NRC MEETING AGENDA  
Meeting of Oct. 6, 1981

Subject: Underground Piping  
Reprofiling started in May 1981

DIESEL GEN BUILDING, DISTAL + 210" (H.C.D. - 16.5 PIPE SETTLEMENT (NORTH-SOUTH))  
 (D. G. B. BLDG. SETTLEMENT FROM (PIPE DRAIN INCLUDE ALL SETTLEMENT TO  
 JAN 26 '79 - APRIL 79) MARK - APRIL 79)

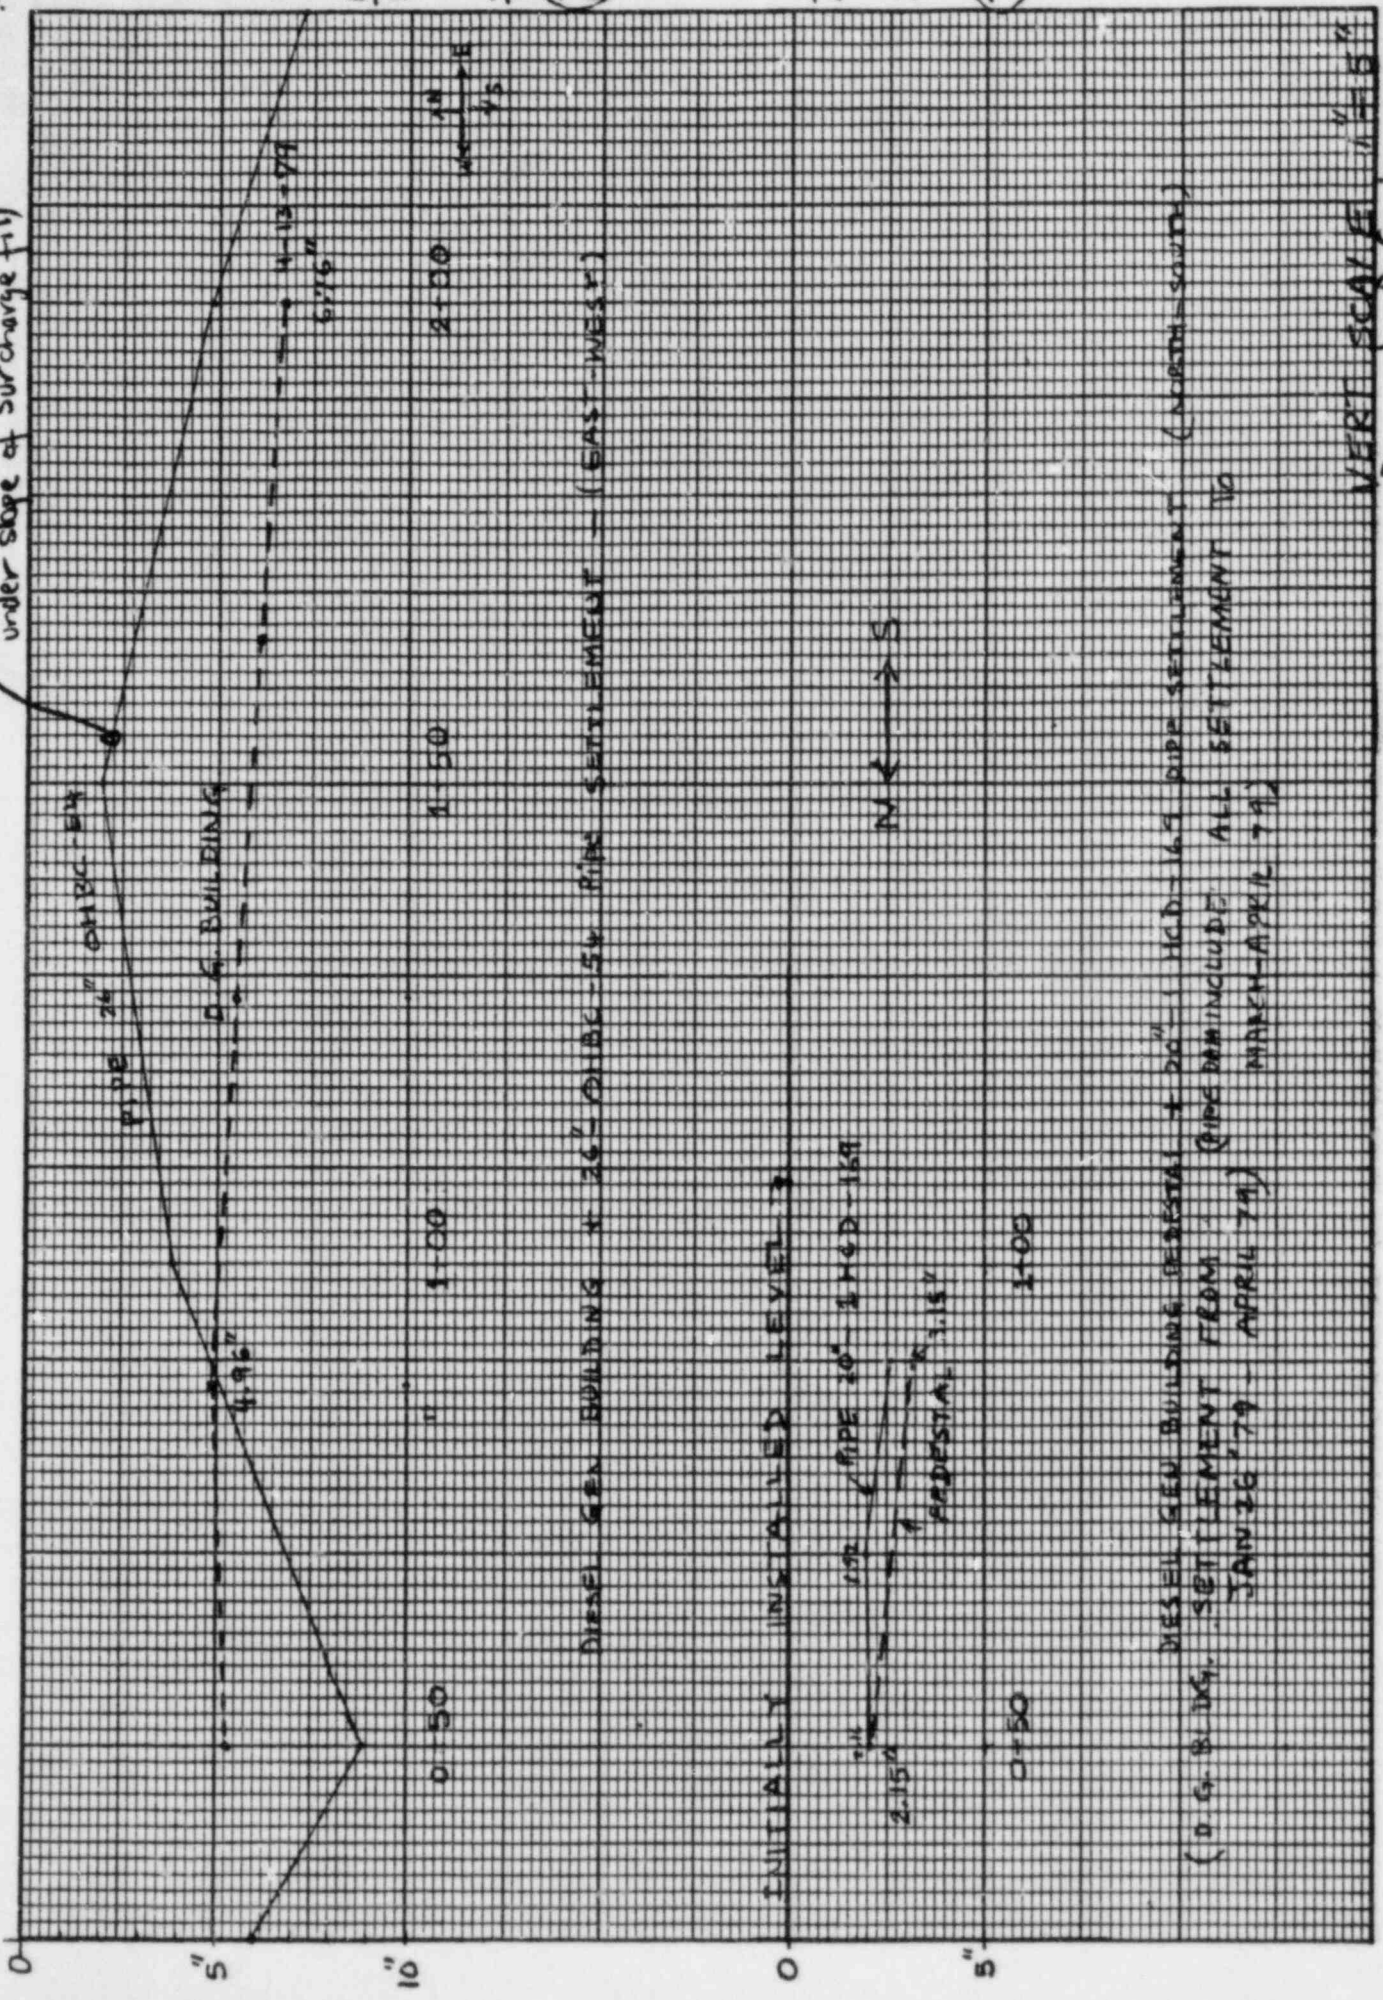
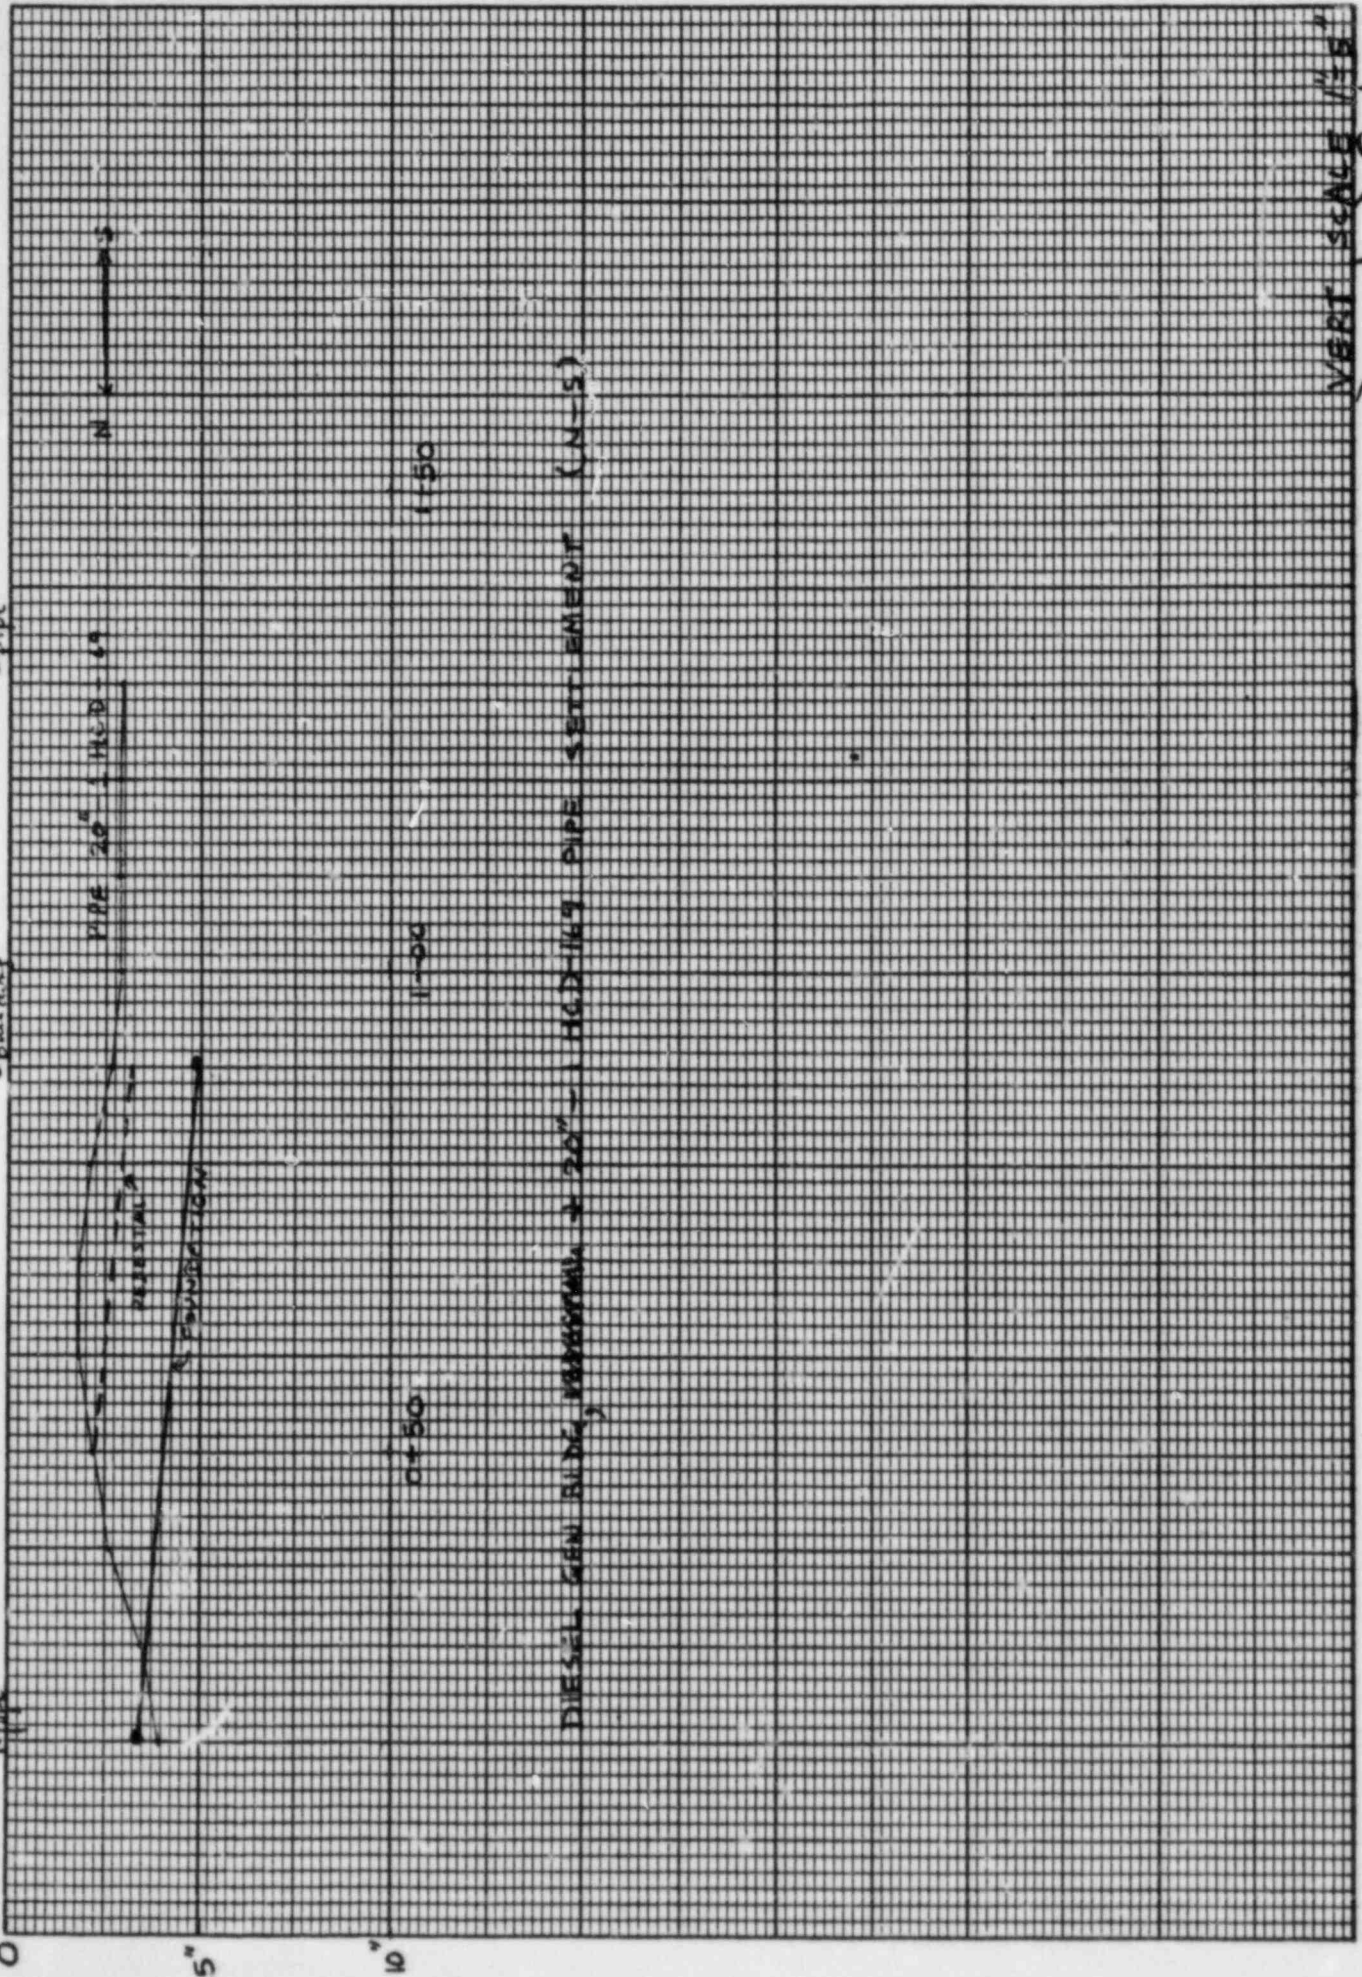
Not under full surcharge load, but  
 under slope of surcharge fill

1.8" / 115' (Rad)

1" / 40' (Rad)
